# MULLEN-BUTLER ADDITION

WICHITA, SEDGWICK COUNTY, KANSAS

RE: S/D 98-114-- One-Step Final Plat of MULLEN-BUTLER ADDITION

**STAFF REPORT**  
**(One-Step Final Plat Approved 12/10/98)**

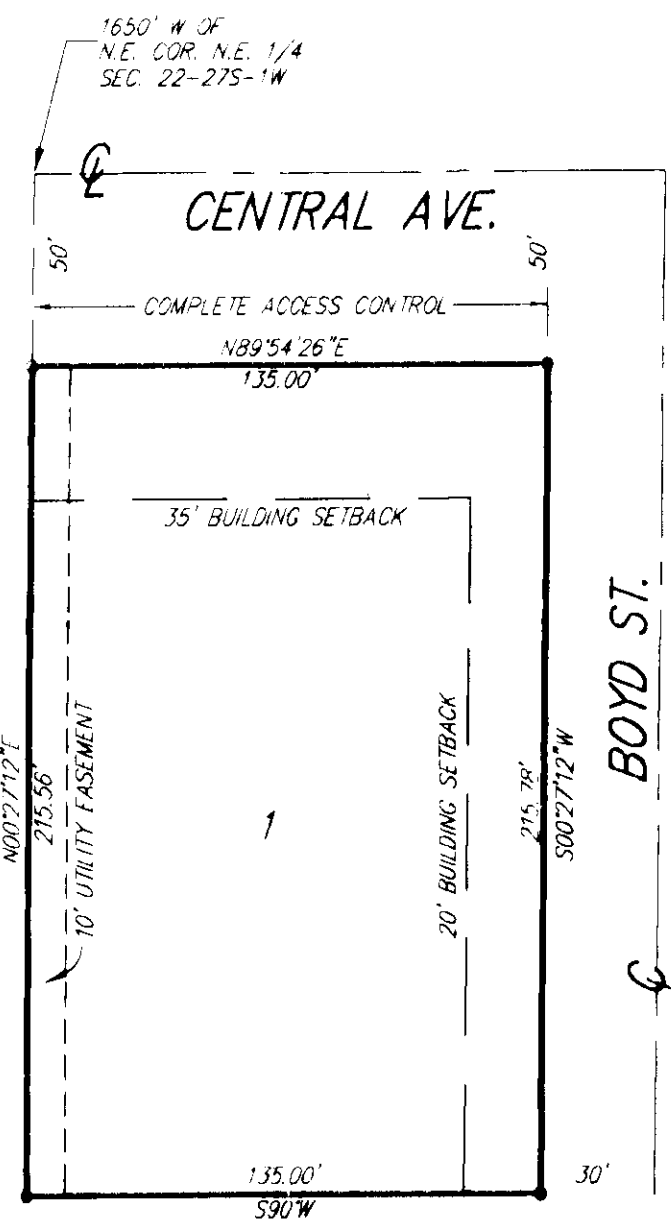
- A. Existing municipal services appear to be available to serve this site. City Engineering needs to verify if any other additional guarantees are required. *The 8-foot utility easement needs to be increased to 10 feet. The Applicant shall attempt to obtain a valid paving petition for Boyd or in the alternative, submit a paving petition for the portion of Boyd adjoining this plat.*

- F. The applicant proposes to continue the use of the existing access opening along Central. **Traffic Engineering** needs to comment on the need for complete access control along Central, and requiring access from Boyd. **Traffic Engineering has required complete access control along Central, limiting access to Boyd.**

- H. The MAPC Chairman needs to be revised to read, "William M. Johnson".
- I. The applicant shall install or guarantee the installation of all utilities and facilities which are applicable and described in Article 8 of the MAPC Subdivision Regulations. (Water service and fire hydrants required by Article 8 for fire protection shall be as per the direction and approval of the Chief of the Fire Department.)
